***BALSHAM PARISH COUNCIL***

**Application by Kingsway Solar Farm Ltd – Scoping Consultation**

Balsham Parish Council has read and reviewed Kingsway Solar's Environmental Impact Analysis Scoping Report and has had input from concerned residents.

*Photo: from the Fleam Dyke towards West Wratting showing the wind turbines on area B*

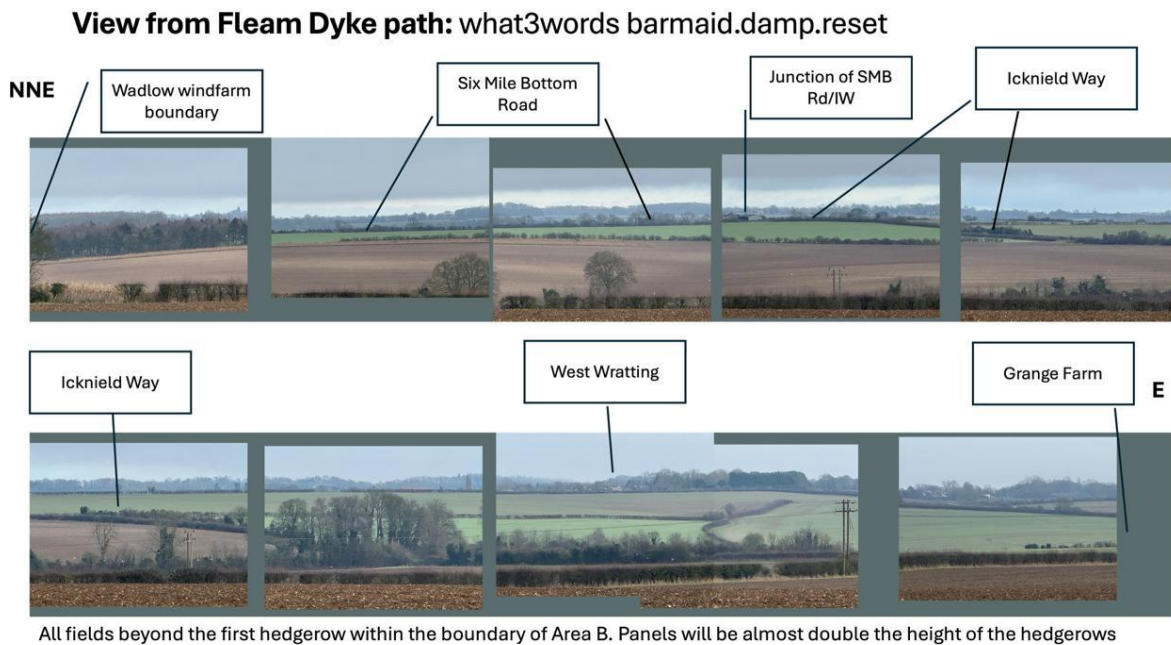
Section 6 describes the landscape as having rolling, gently undulating hills and clay woodlands with "long distance and open views" across the area. The elevated land in the middle of area B, with its 13 wind turbines, is visible from many miles away, particularly along the Fleam Dyke and Icknield Way footpath. Co-locating the solar farm in this area, as suggested in the plans, would make the new infrastructure highly visible.

Balsham residents frequently use the Fleam Dyke and Icknield Way (Fox Road) in Area B, as well as the Roman Road in Area A near Balsham. Both are popular routes for walking, cycling, and other recreational activities. They hold historical significance and local value, contributing to the area's character and providing an important connection to the surrounding landscape. The solar farm will have a significant impact on regular users of these routes.

This is a photo montage of a view of Area B from the Fleam Dyke path showing that screening of this area will be impossible.

The potential of a new construction road discussed in the 'Traffic and Transport' (Page 7) would run through the middle of this picture. Whatever Kingsway does to land area B, and the way they construct it, the impact on the village will be huge. The scoping EIA document does not reflect this or addresses the correct data analysis to assess it.

**Action required:** Detail any access roads and proposed routes.
